Final Reclamation Inspection

Replugging Operator: BARRETT CORPORATION* BILL (BBC)- 10071

API: 05-123-09893

Inspection Photos
Location Name: BURKE #1
API: 05-123-09893

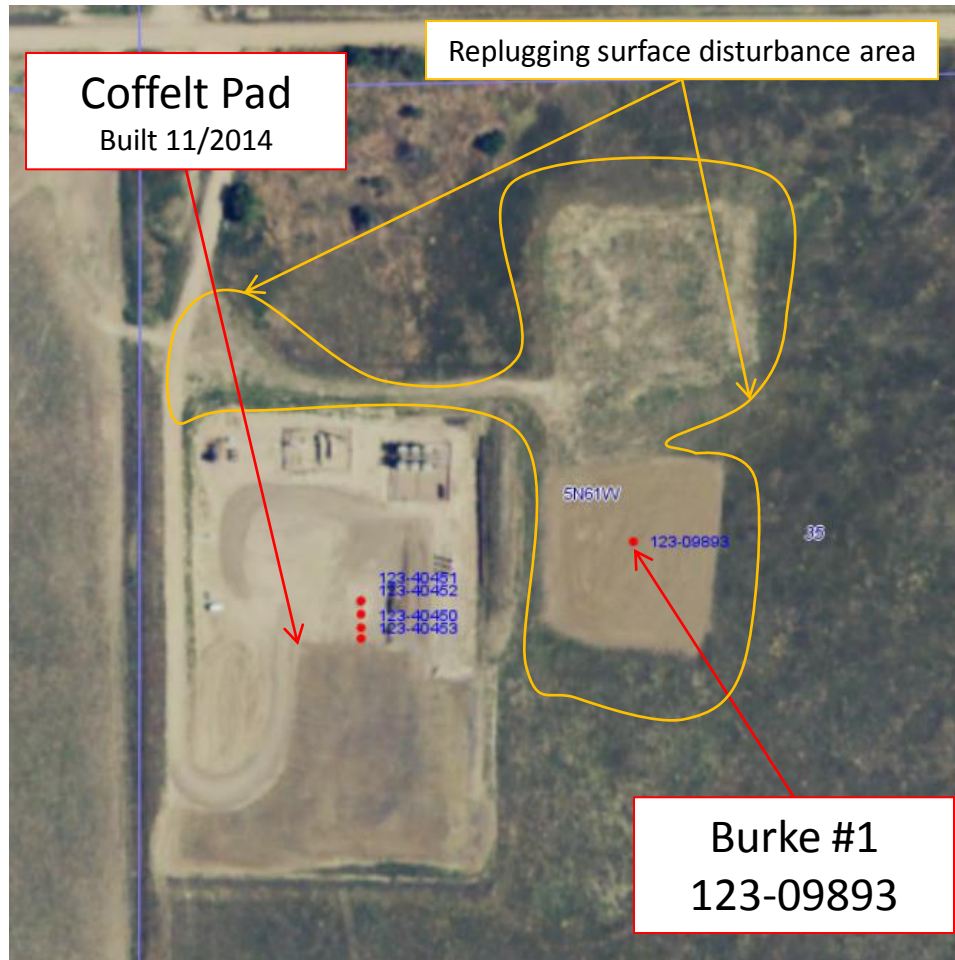
Aerial imagery take in 2015. Imagery illustrates surface disturbance from replugging operations performed by BBC. Well was replugged 12/2/2014. Operator shall comply with Rule 1004 standards for the entire replugging surface disturbance area shown above.

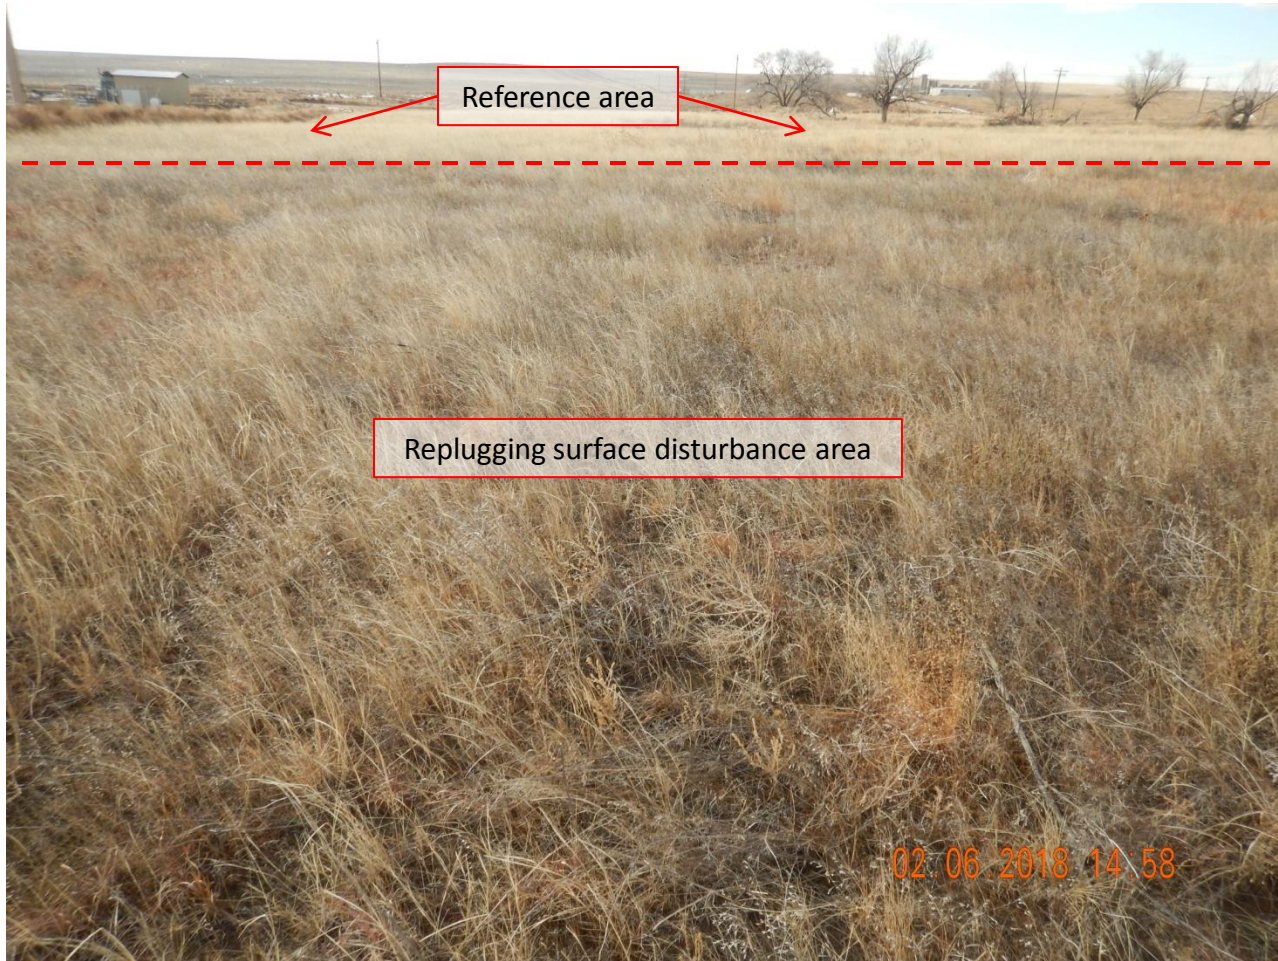
Photo 6. Photo taken from the approximate center of the northern replugging disturbance area, facing West. See comments under Photo 5.
